# Access Compliance Report

## Public Rights-of-Way

### (Curb Ramps)

Intersection ID: 10024054	Main Street: CORONATION_BV	Cross Street: N/A	Location: SE
ADA ID: 5007E2257D34	Ramp Type: Perp	Initial Pass/Fail: Fail	Overall Compliance: No
Severity Score: 26.25			
Codes/Mitigation Info/Possible Solution		Field Measurements/Component Compliance

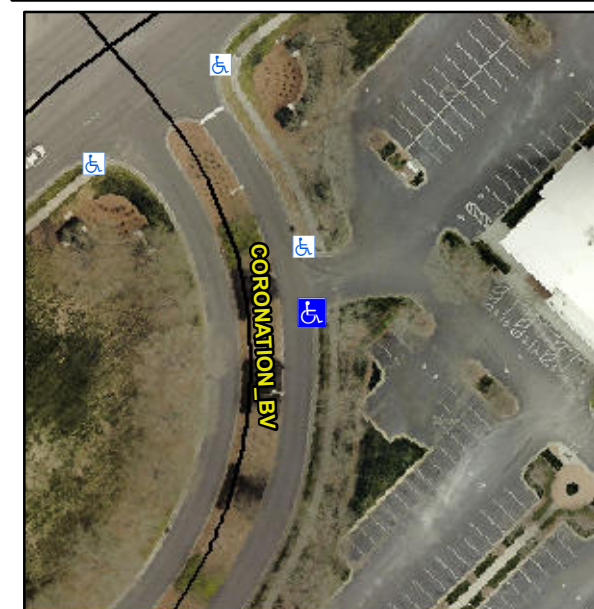
**Not Found, R304.2.2**

Compliance	Description	Data	Compliance	Description	Data
N/A	Ramp Length (in)	83.0	No	Ramp Slope (%)	12.9
Yes	Ramp Width (in)	48.0	Yes	Ramp XSlope (%)	3.9
N/A	Flare Type LT	N/A	N/A	Flare Type RT	N/A
N/A	Flare Slope LT (%)	N/A	N/A	Flare Slope RT (%)	N/A
N/A	Flare Traversable LT?	N/A	N/A	Flare Traversable RT?	N/A
N/A	Landing Length (in)	N/A	N/A	DWS Provided?	N/A
N/A	Landing Width (in)	N/A	N/A	DWS Contrast?	N/A
N/A	Landing Slope (%)	N/A	N/A	DWS Length (in)	N/A
N/A	Landing X Slope (%)	N/A	N/A	DWS Full Width?	N/A
N/A	Landing Curb? (Y/N)	N/A	N/A	DWS Offset (in)	N/A
N/A	Shared Landing?	N/A			
N/A	Gutter Ponding?	N/A	N/A	Gutter Slope (%)	N/A
N/A	Gutter Lip Ht (in)	N/A	N/A	Gutter X Slope (%)	N/A
N/A	Painted X Walk1?	No	N/A	Painted X Walk2?	N/A
	X Walk 1 Direction	To N		X Walk 2 Direction	N/A
N/A	X Walk 1 Width (in)	N/A	N/A	X Walk 2 Width (in)	N/A
	X Walk 1 Slope (%)	0.6		X Walk 2 Slope (%)	N/A
	X Walk 1 X Slope (%)	4.6		X Walk 2 X Slope (%)	N/A

**Remove & Replace Entire Ramp.**
